# 1966 Corvette: Service Bulletin: Air Pump Noise - Air Injection Reactor System

**Source:** Chevrolet Technical Service Bulletin

**Bulletin No:** TSB #66-62

**Date:** May 20, 1966

## Date Code

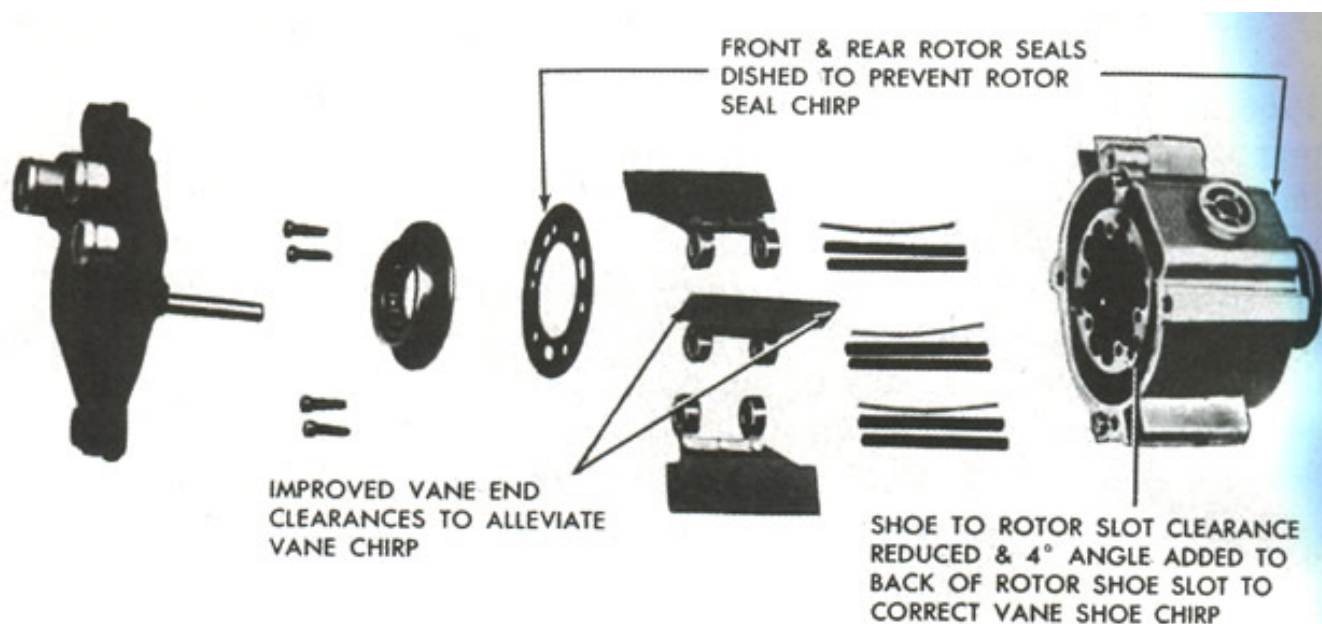
In production, beginning with date code 0126XX stamped on the pump housing, improvements have been incorporated as noted on page 2, to alleviate the above conditions.

If upon completion of the above, the "chirp" still persists, or if the "chirp" is heard at higher pump speeds, the entire pump assembly must be replaced with a pump having a date code of 0126XX or later. Control of pump service components is such that there is no identifying feature to indicate the latest improvements.
